## Nebraska Public Power District

NLS2004128  
October 12, 2004

**Subject:** Regulatory Conference - Request for Additional Information  
Cooper Nuclear Station, Docket 50-298, DPR-46

**Reference:** Nuclear Regulatory Commission (NRC) Inspection Report  
05000298/2004014, dated August 12, 2004

615W101A SCAN  
Figure 1

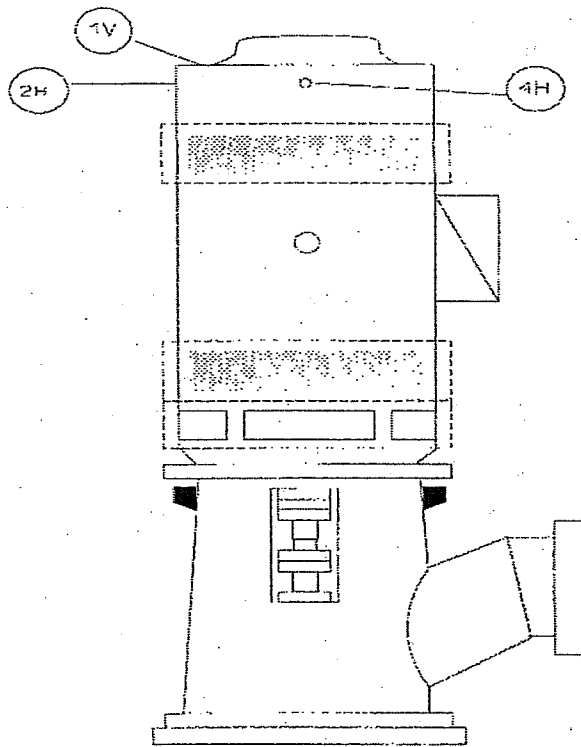
The most recent B and D Service Water (SW) Pump Vibration Data, including alert and action levels, prior to the condition that existed when the SW valves were mispositioned.

The most recent vibration data for the B and D SW pumps prior to the condition was from the 1/5/04 performance of 6.2SW.101, "Service Water Surveillance Operation". The following is the data obtained:

Recorded Value	Alert Level	Action Level
<b>B SW Pump</b>			
Location 1V	0.079	0.325	0.700
2H	0.116	0.325	0.700
4H	0.100	0.312	0.700
<b>D SW Pump</b>			
Location 1V	0.115	0.270	0.648
2H	0.105	0.275	0.660
4H	0.049	0.170	0.408

Locations can be seen in Figure 1 on Page 2 of this Attachment.

Figure 1

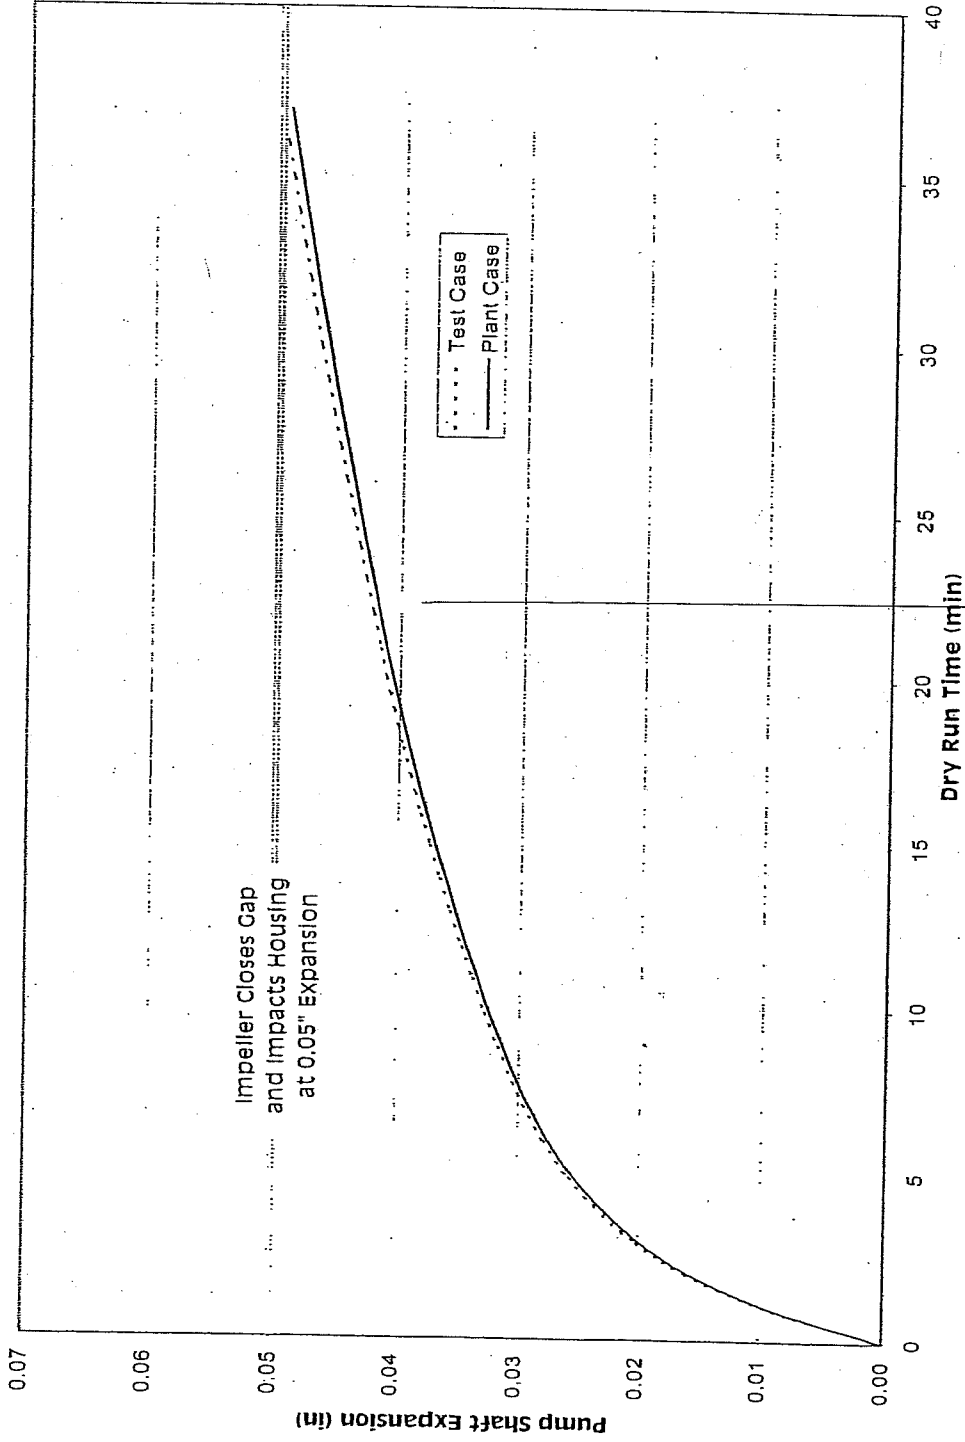
What is the difference in shaft expansion for the test conditions compared to the cooler water that existed during the 21 day period?

The thermal expansion of the shaft during the test conditions and during the 21 day plant conditions will be approximately the same, with the plant case expansion slightly less than the test case. The expansion is nearly the same because the two main parameters that change from one case to the other (water temperature and starting pump shaft temperature) approximately cancel each other out when comparing the two cases.

Test Case: Using the initial estimated heat generation rate at the shaft/bearing interface, the shaft was found to heat up and thermally expand 0.05" in approximately 15 minutes of dry operation. Therefore the impeller would contact the bowl in 15 minutes, whereas during the test, contact occurred after approximately 37 minutes. To calibrate the model with the test results, the heat generation rate was reduced to cause the shaft to expand 0.05" in approximately 37 minutes. The pump shaft expansion as a function of time is shown in Figure 1. Using the calibrated heat generation rate, the shaft axial expansion after 37 minutes was 0.050".

Plant Case: The model was re-analyzed for the extreme plant operating conditions (bay temperature of 43°F and water temperature of 38°F due to loss of de-icing flow into the river water). The starting temperature of the pump components and the water temperature were changed to the plant conditions. The calibrated bearing heat generation rate was used in the analysis. The results of the analysis are shown in Figure 1. The results in Figure 1 show that the shaft expansion for the test case and the plant case are very similar - the two curves lay almost on top of each other. The pump shaft thermal expansion after 37 minutes was 0.049", about 2% less than the expansion calculated for the test case.

The results in Figure 1 show the shaft thermal expansion up to the point where the impeller makes contact with the pump bowl. After that point, the expansion will follow a steeper curve as a function of time. This occurs because impeller contact causes compressive and lateral loading of the shaft, which results in increased shaft orbiting, much larger bearing loads, and greater heat generation. The increased bearing loads and heat generation caused the severe bearing damage observed on the test pump. Also during this period, impeller and bowl material are being removed. Finally an equilibrium point is reached after about 3.5 minutes, when bearing heat generation has peaked and no additional shaft expansion occurs. After approximately 7.5 minutes, stable pump operation resumes. This series of events, including the total shaft expansion and amount of material removed by the impeller scraping the bowl, will be essentially the same for the test case and for the plant case.

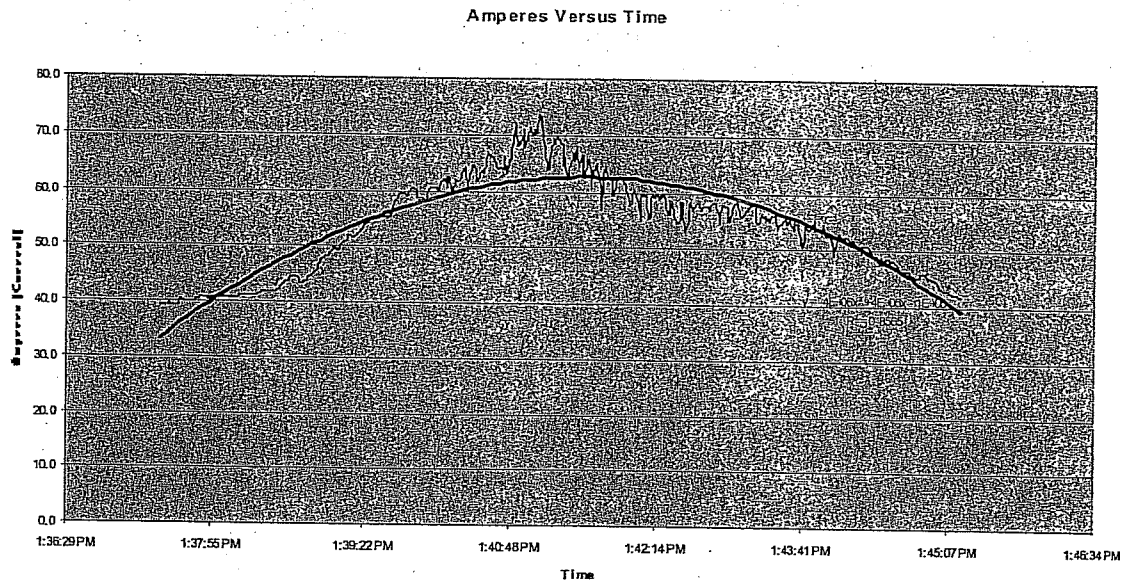
How much more force would it take to cause a pump/motor breaker trip (overcurrent)?

In order for the pump motor to trip on overcurrent, the force would have to nearly double (increase approximately 85%). However, as supported by the response to the question on shaft elongation, there is no mechanism present that would cause the heat-up rate of the shaft to increase.

During the impeller/bowl grinding period, which was about 7 minutes, slightly less than 38 mils of material was removed. This is a removal rate of approximately 5.4 mils per minute. The reason for the increased expansion rate during the impeller/bowl grinding period is due to the shaft being under compression. This results in the shaft orbiting, creating higher lateral bearing loads, which in turn causes more friction between the bearings and shaft, causing the shaft to heat up at a faster rate. However, once the temperature of the bearing approaches 300 degrees F, the rubber breaks down and portions peel away, thus limiting the mechanism (i.e., resistance between the shaft and bearing) for further increase in temperature. Once again, during this 7 minute period of time where grinding occurred, the heat up and cooldown process follows an exponential curve based on Newton's Law of Cooling. This is noted in the following graph, which has a parabolic curve fitted to the ampere data.

Thus, the power needed by the motor to sustain the machining rate between the impeller and bowl would not have been much more than that already recorded in the test. Note that the parabolic curve fit in the graph has a fit "R" value of 93%, which is a good correspondence.

When the pump was just pumping water, it used approximately 39 amperes. The maximum current used by the motor was about 73.6 amperes during grinding of the impeller into the bowl liner. Thus, approximately 39 amperes was being used to pump water, and about 34.6 amperes was being used to remove metal at a rate of 5.4 mils per minute.

In order to reach a current consumption of 103 amperes, which is the trip setpoint, the downward force due to shaft elongation would need to be increased such that the current consumption is increased from 34.6 amperes to 64 amperes. This would require the force be increased by approximately 85%.
